# Work Order ID 125054

Item Name: Crosstube Turning Detail

<b>DART AEROSPACE LTD</b>		<b>Work Order:</b>	125 054
<b>Description:</b> Crosstube Assembly		<b>Part Number:</b>	D407-667-145
<b>Inspection Dwg:</b> D407-667-145 Rev: C		<b>Page 1 of 2</b>

DRAWING NO. D407-667-145	TITLE CROSSTUBE ASS'Y (407 HIGH FWD)	REV. C	DART AEROSPACE LTD ENGINEERING ORDER		D.E.O. NO. D407-667-145-C-1	SHEET NO. SHEET 1 OF 1	SCALE NTS
DRAWN 90	CHECKED ASS	MFG. APPR. 188	APPROVED WD		DE APPR. H		
DATE 11.07.15	DATE 11.07.22	DATE 11.07.22	DATE 11/07/22		DATE 11.07.21

**TURNING DETAIL**

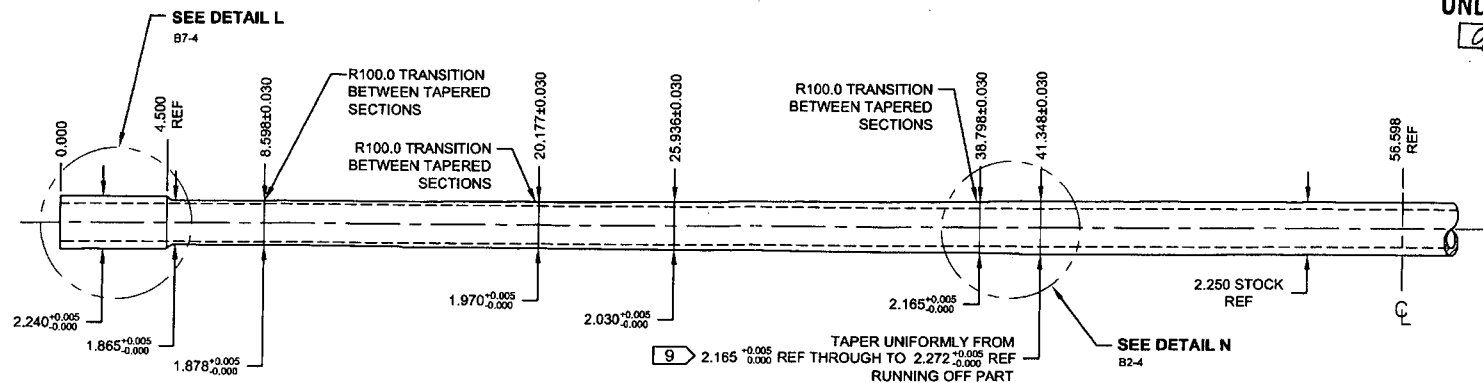
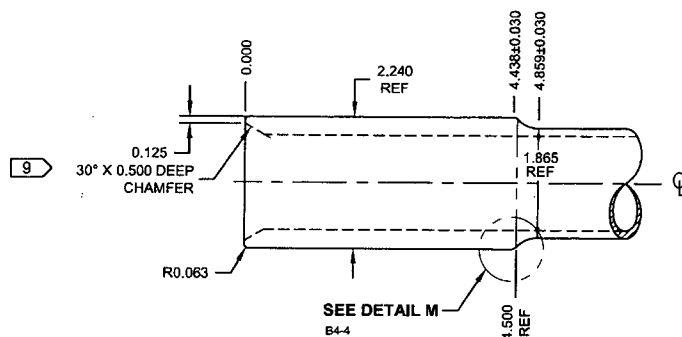
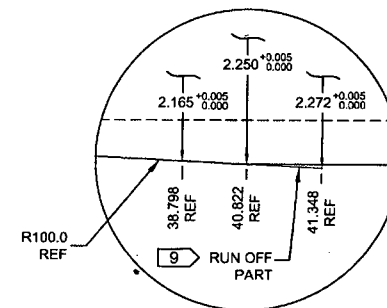
C	REVISE GENERAL NOTES/PART LIST (ZN D7-1); REORGANIZED VIEWS AND REFORMATTED DRAWING TO CURRENT STANDARDS. D3595-063-395 WAS D2856-400-694 (ZN D6-2 & A5-2); REMOVED REF. 7 ADD TOLERANCES (ZN C6-3, C4-3, D2-3); RELOCATED FLAG #6 (ZN A8-3) PER NCR 210; MOVED TURNING DETAIL & UPDATED TOLERANCE TO SHEET 4.	RF	08.11.06
B	ADD HOLES AND NUT PLATES FOR COMPATABILITY WITH BHT/AA SKUDTUBES	PH	05.07.26
A	NEW ISSUE	CP	02.05.08
REV.	DESCRIPTION	BY	DATE
DESIGN	RF	DART AEROSPACE LTD	
DRAWN	RF	HAWKESBURY, ONTARIO, CANADA	
CHECKED	RF	DRAWING NO.	REV. C
MFG. APPR.	RF	D407-667-145	SHEET 1 OF 4
APPROVED	RF	TITLE	SCALE
DE APPR.	RF	CROSSTUBE ASS'Y (407 HIGH FWD)	NTS
DATE	08.11.06	COPYRIGHT © 2002 BY DART AEROSPACE LTD THIS DOCUMENT IS PRIVATE AND CONFIDENTIAL AND IS SUPPLIED ON THE EXPRESS CONDITION THAT IT IS NOT TO BE USED FOR ANY PURPOSE OR COPIED OR COMMUNICATED TO ANY OTHER PERSON WITHOUT WRITTEN PERMISSION FROM DART AEROSPACE LTD.

**DETAIL P**  
BONDING STRAP INSTALLATION 2 PL

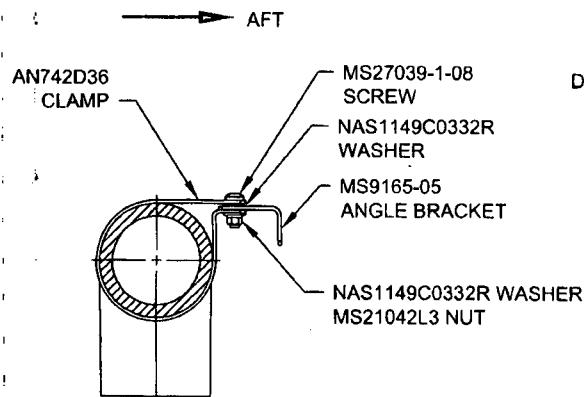
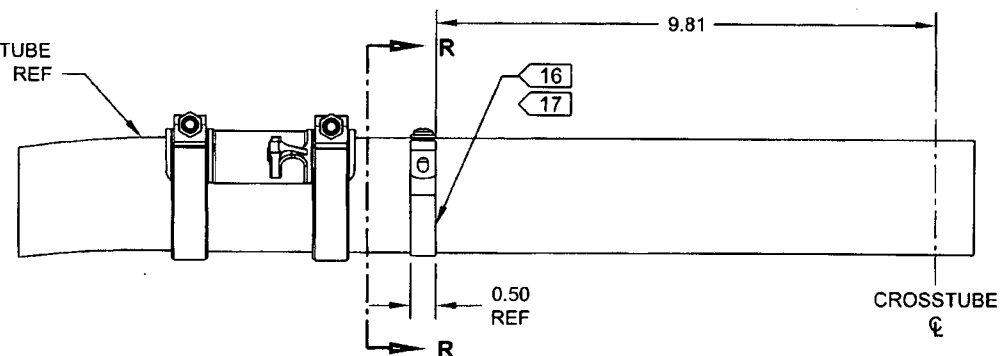
ADD ELECTRICAL GROUNDING STRAP

ITEM	QTY -145	PART NUMBER	DESCRIPTION
1	X	D407-667-145	CROSSTUBE ASSEMBLY (407 HIGH FWD)
10	2	AN742D36	CLAMP
11	2	MS9165-05	ANGLE BRACKET
12	2	MS21042L3	NUT (OR MS21042-3)
13	2	MS27039-1-08	SCREW
14	4	NAS1149C0332R	WASHER (OR AN960C10L)

- 16) MASK AREA UNDER CLAMP PRIOR TO PAINTING
- 17) SEAL EDGES WHERE AN742D36 CLAMP MEETS WITH THE CROSSTUBE USING SIKAFLEX-241/-291 OR MIL-S-8802 CLASS B2 OR PROSEAL 890 SEALANT
- 18) PERFORM RESISTANCE CHECK TO ENSURE MAX RESISTANCE IS 10 MILLIOHMS
